ROLLING KNOLLS LANDFILL SUPERFUND SITE
FEASIBILITY STUDY ASSESSMENT

The Office of Environmental Policy and Compliance

KMPower Consulting, Inc

April 2019

FIGURE 3 - Refuge Area of Interest
Pb Surface Soil Soil Concentrations

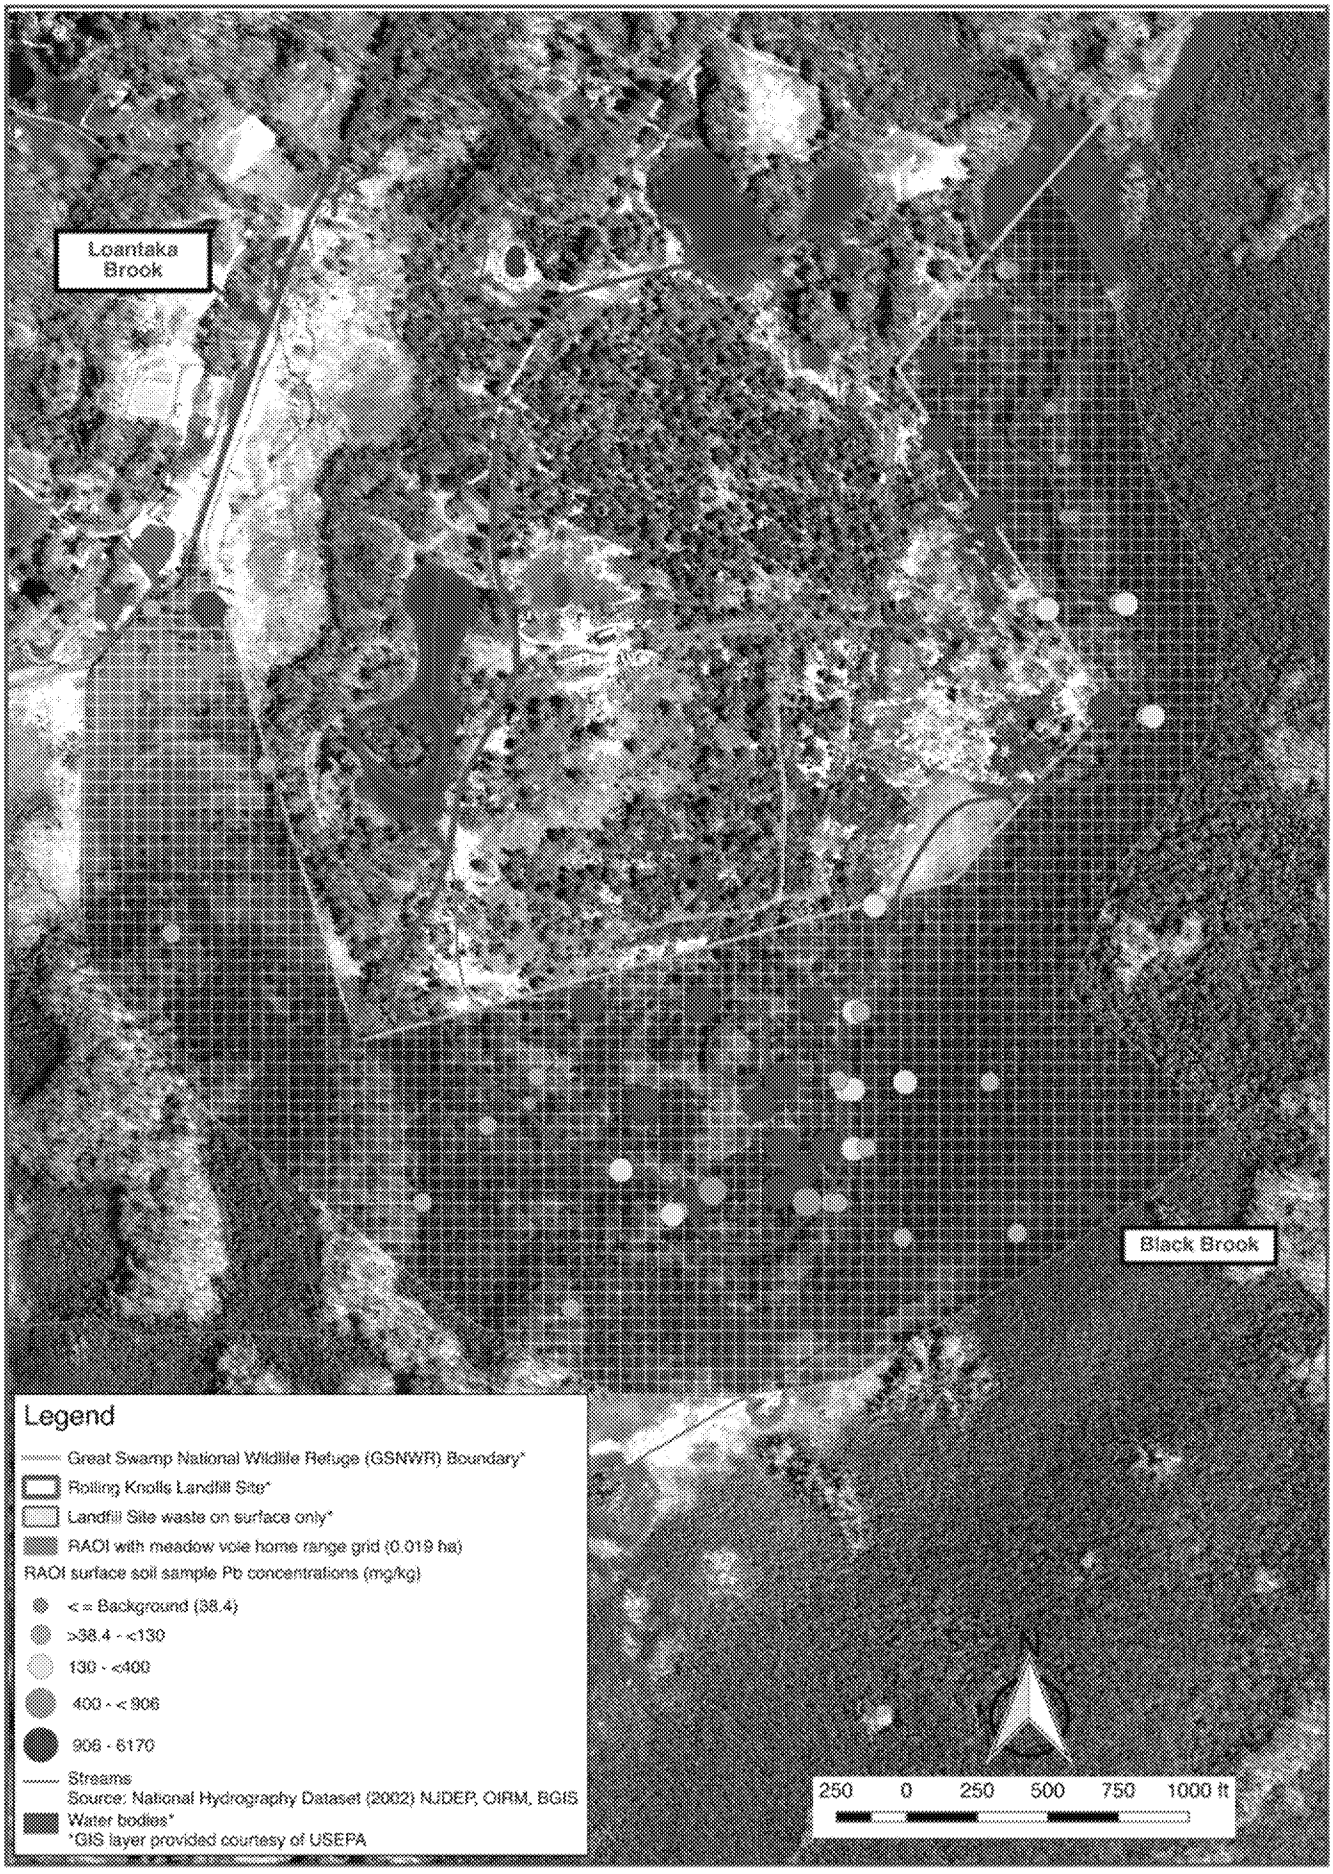
Figure 3 – Figure 3 illustrates several main points of impact revealed by the assessment on the RAOI property from Table 1. Features of Figure 3 include:

- As indicated above and illustrated on Figure 3 a significant portion of the soils with Pb contamination exceeding the Table 1 benchmarks on the RAOI are found in the South/Southeast impacted area of the RAOI. An area of approximately 17.8 acres contains all the sample locations with Pb concentrations higher than the 400 mg/kg benchmark concentration and includes measured concentrations as high as 6,170 mg/kg. Furthermore, this area is only characterized by 23 samples (i.e., approximately only 1.3 samples per acre; see also discussion below regarding Figure 4). Potentially, localized regions or 'hot spots' could be present that have not been identified. As indicated on Figure 3, relative to the herbivorous mammal exposure areas (the 2045 ft^2 cells, voluminous uncharacterized areas are present in the South/Southeast impacted area of the RAOI.

FIGURE 4 - Refuge Area of Interest
Pb Surface Soil Impacted Areas

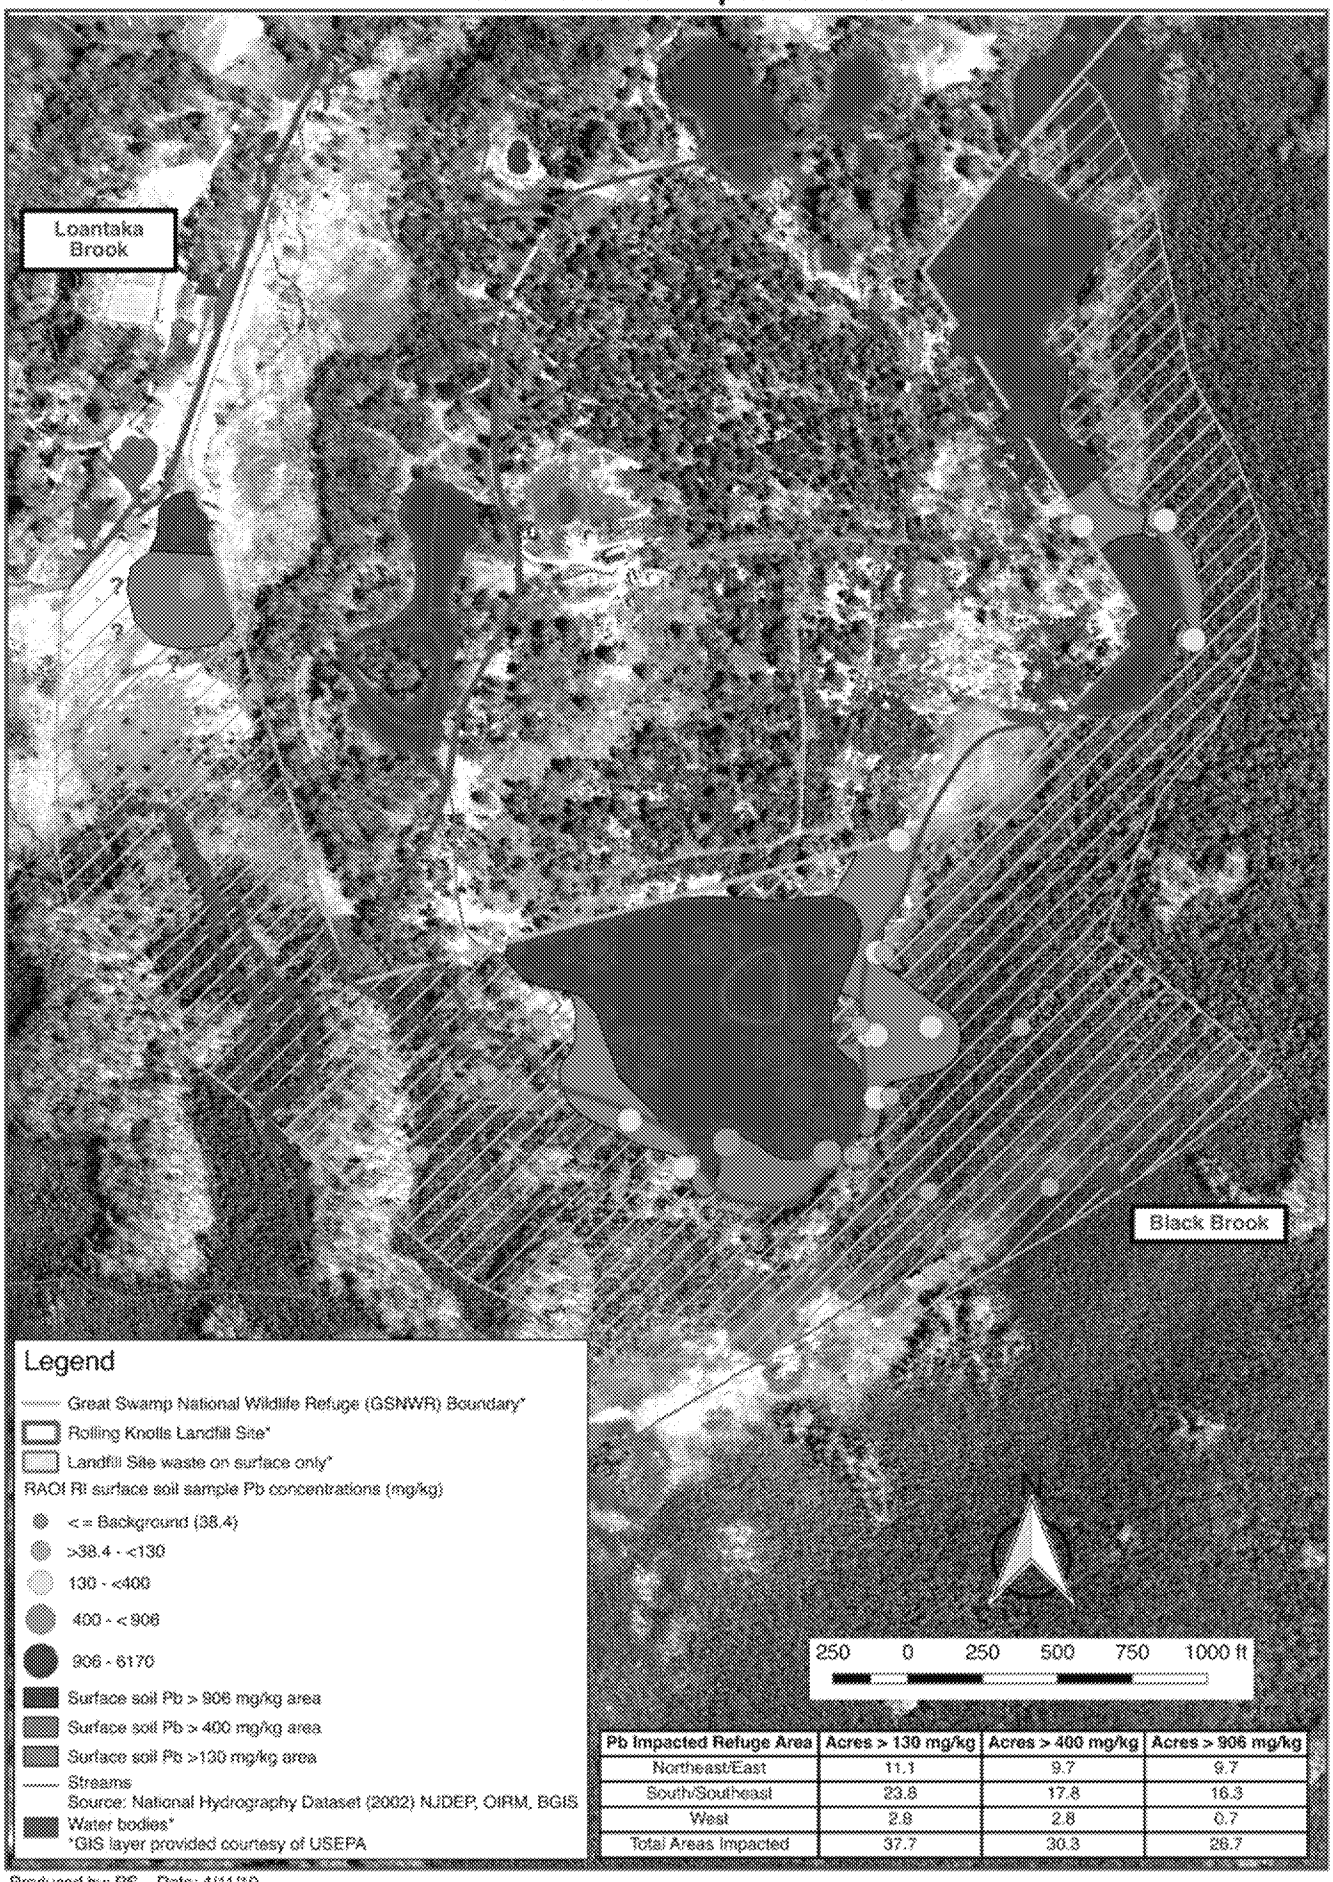
Figure 4 – The extent of lead contamination in the RAOI is further illustrated in Figure 4. Polygons were created to delineate approximate areas of contamination exceeding the key benchmarks. The polygon boundaries were determined based on their proximity to adjacent samples, the Pb concentrations of adjacent samples, and professional judgment. A review of the data illustrated on Figure 4 results in the following observations.

1. It appears that a significant area of the impacted RAOI area surface soils may contain Pb concentrations exceeding the meadow vole NOAEL-based protective benchmark concentration of 906 mg/kg, including:
    - The Northeast/East (9.7 acres).
    - The South/Southeast portion (16.3 acres).
    - The West area (0.7 acres), which is located outside of the landfill boundary/currently-defined Site.

2. Based on the distribution of contaminant concentrations, it is likely that a sizable portion of the RAOI may contain areas where Pb surface soil concentrations exceed the assessment benchmark concentration of 400 mg/kg including:

3. Figure 4 also indicates that a significant area of the impacted RAOI area surface soils may contain Pb concentrations exceeding the Short-tailed shrew NOAEL-based protective benchmark concentration of 130 mg/kg, including:
